Project: Prince Place Lot 11
Location: Fuquay Varina, NC
Company: Davidson Homes
Care Of: Lee Aversano
Subject: Notched Porch Header
Job Number: 2-1545-22

As requested, Andy Takla, PE prepared this report on March 30th, 2022 to provide formal documentation of our acceptance of the following:

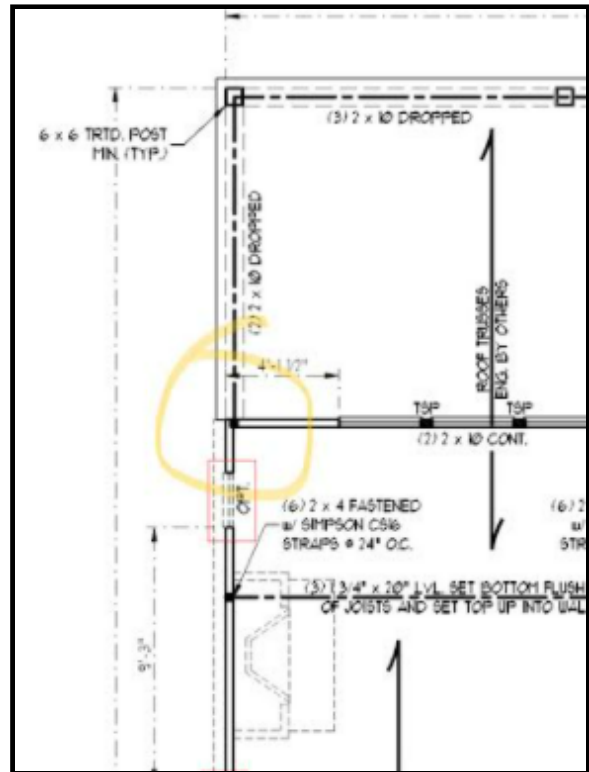
Rear porch left-side header ((3)2x10)) is notched ~ 1/2" where pocketed in the wall. See pictures below for additional reference.

Conditions are tolerable; No repairs needed.
